## CHAPTER 34 – HIGHLIGHTS

*Revision No. TR34-4 September 26/19*

TO: HOLDERS OF THE WIRING DIAGRAM MANUAL (06-117753)

**TR34-4 supersedes TR34-3.**

Figure 1 (Sheet 1 of 2)

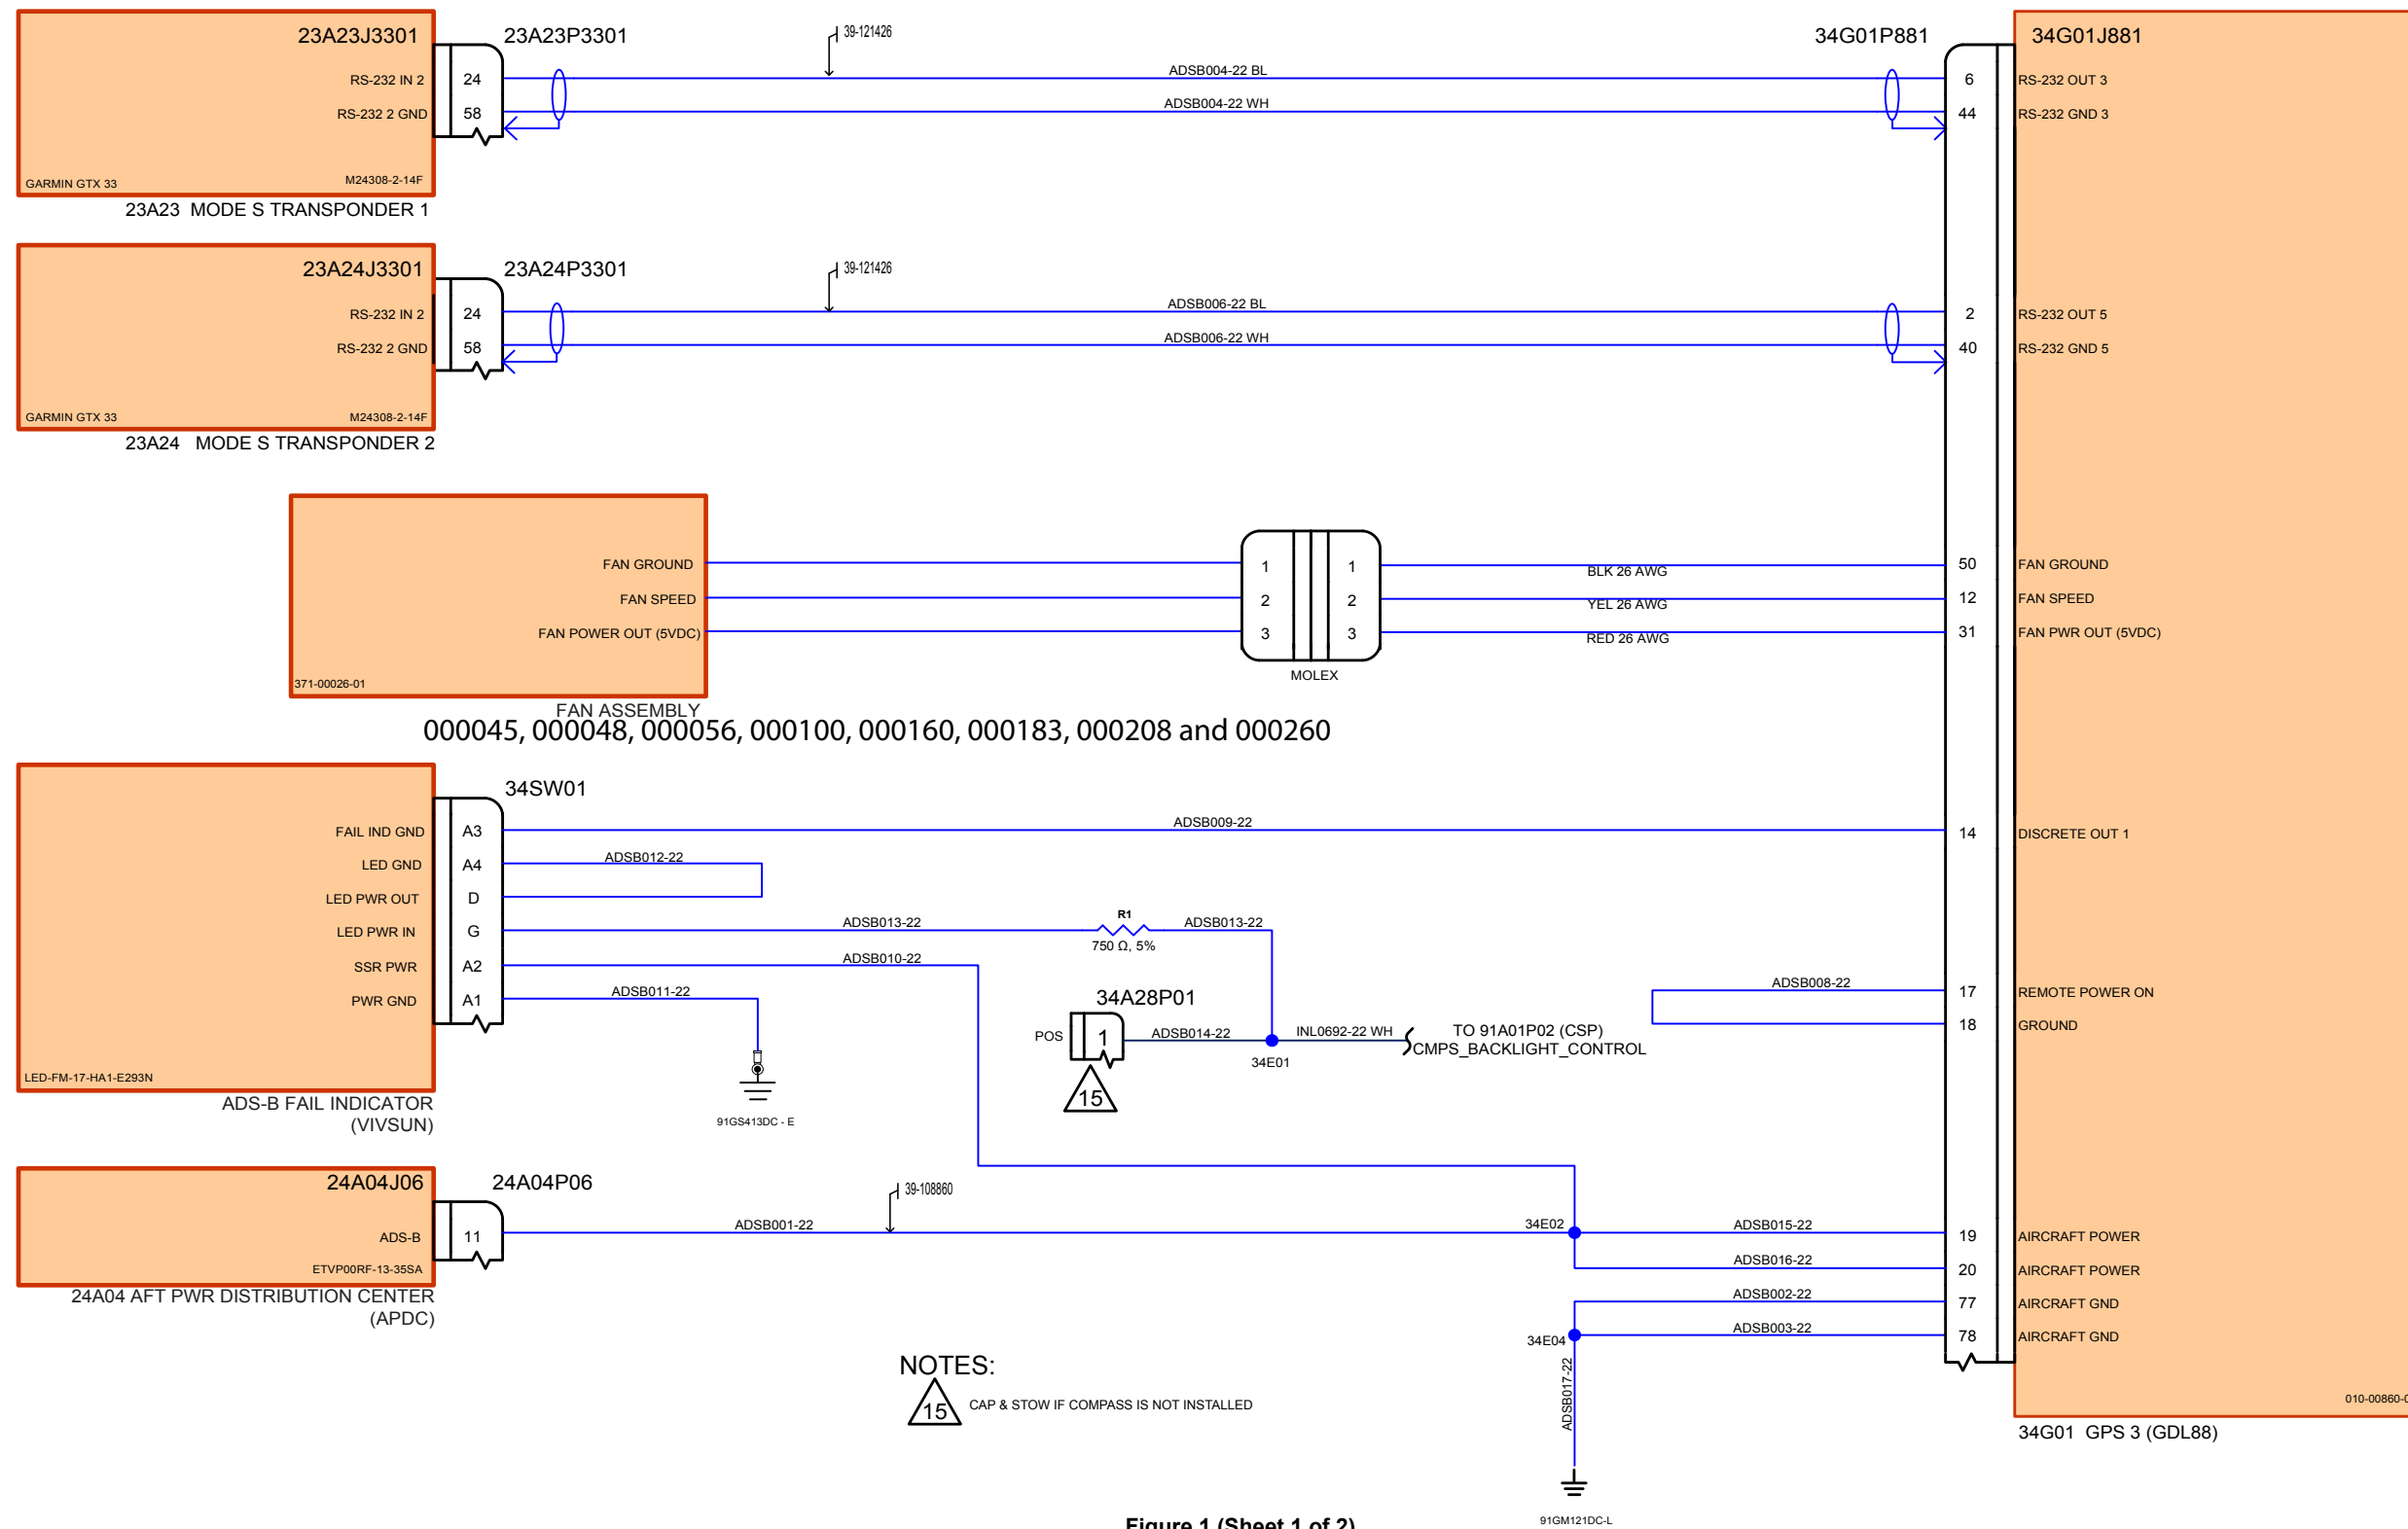
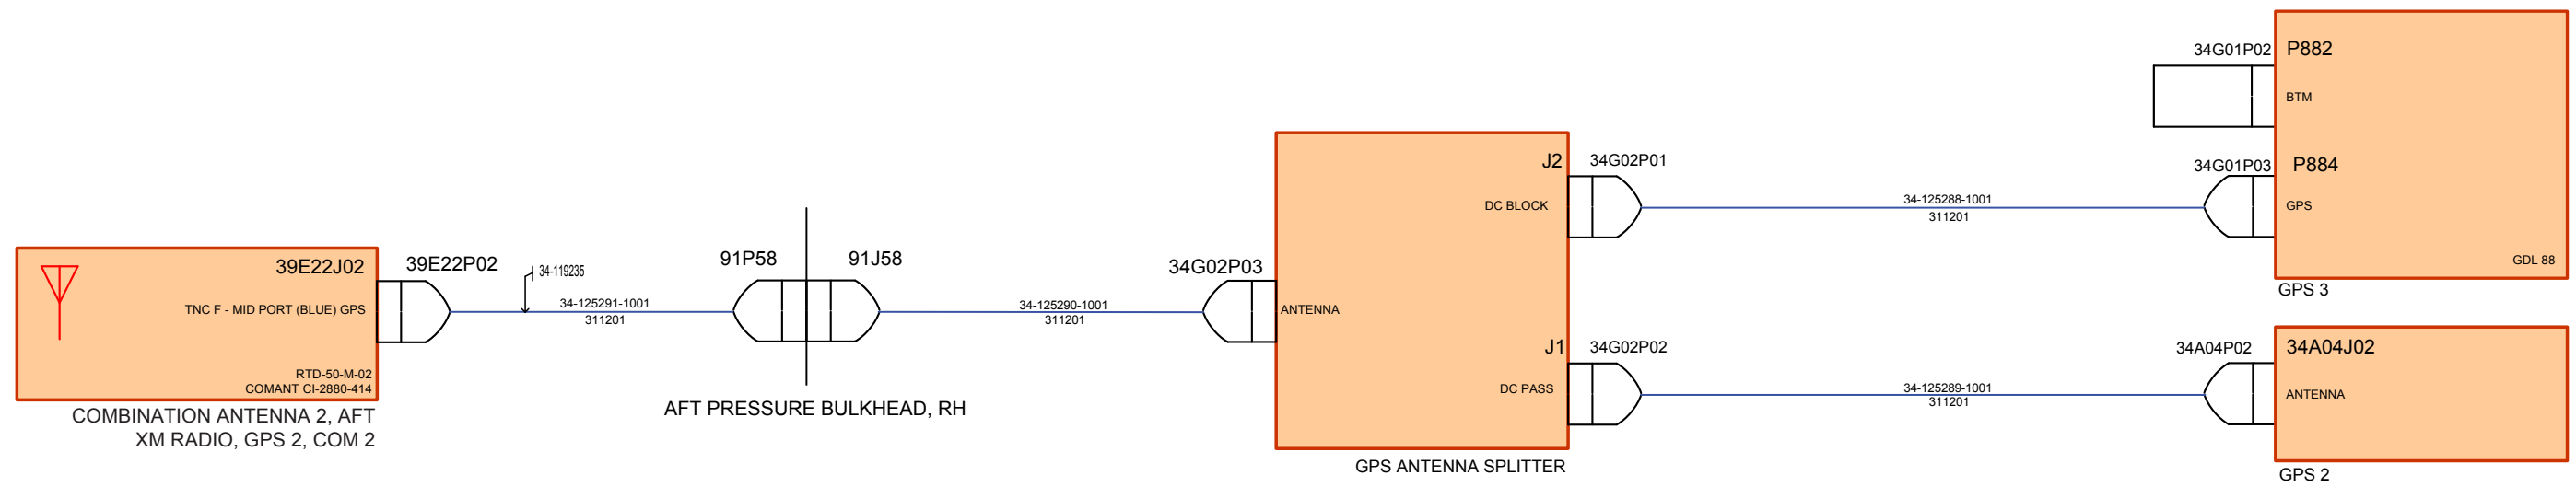
CH/SE/SU	Description of Change
34-50-20	Chapter 34, "Navigation Systems," has an optional set of ADS-B Upgrade diagram pages. These pages apply only if the ADS-B Upgrade has been installed to the aircraft  Figure 1 shows the in-line attenuating resistor to the ADS-B Fail Indicator. POST MB 500-34-030  Figure 2 shows the in-line attenuating resistor to the ADS-B Fail Indicator removed. POST MB 500-34-031.
